PROJECT 2529

MEMORY AND BAY GATES;

BAY-SELECTOR SWITCH

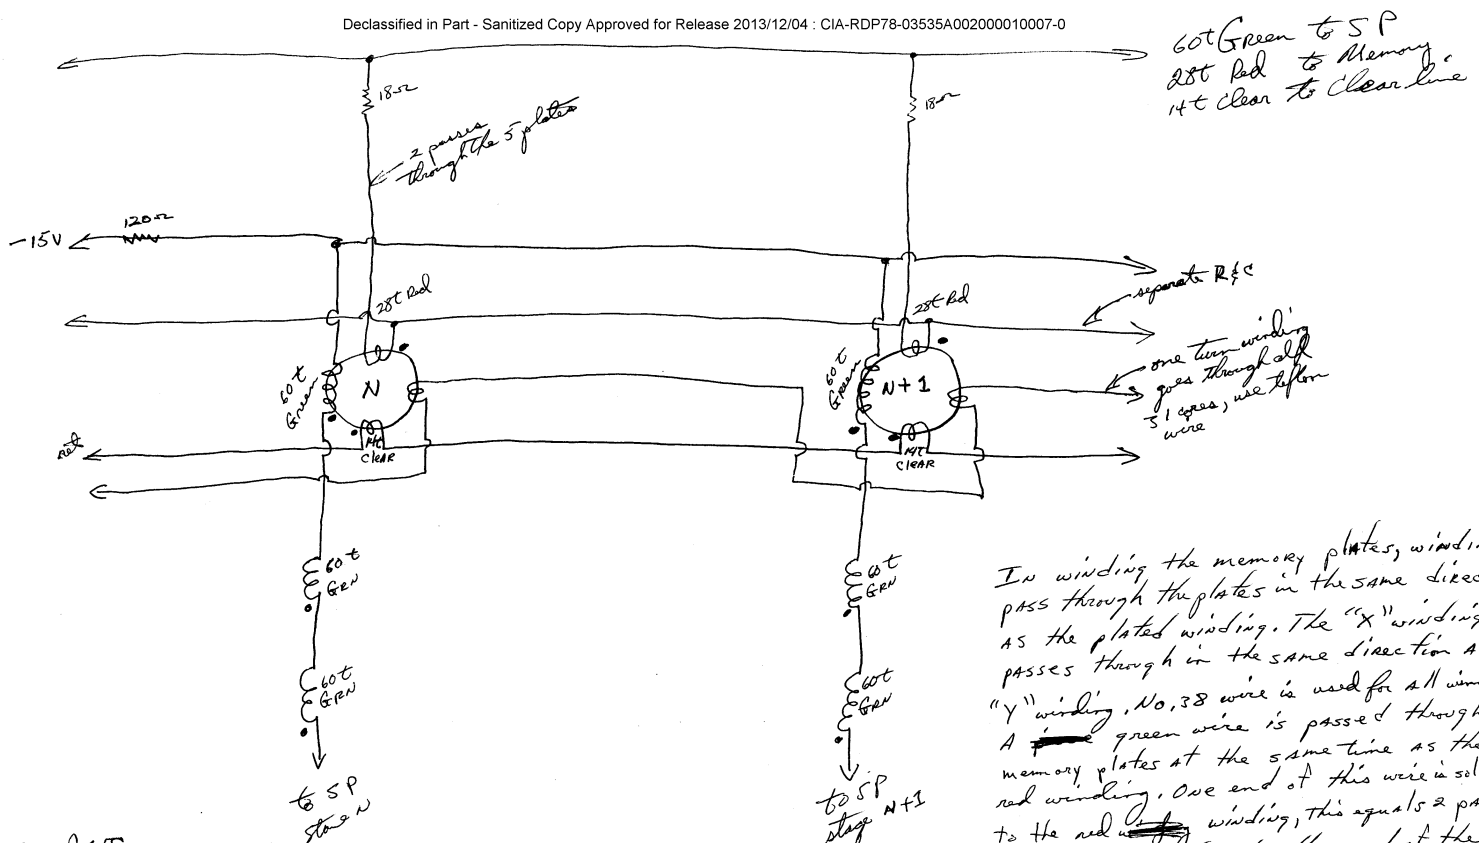
- Notes
- ② - ~~1.052~~ "for passing 60T to next board"
 - ① - .020" holes for 120R resistors
there are 8 Resistors altogether
16 stage SP { 3 R's with 5 wires each
1 R with 1 wire
15 stage SP { 2 R's with 5 wires each
1 R with 4 wires
1 R with 1 wire

has been
switched around
in 3rd BA
12/12/57
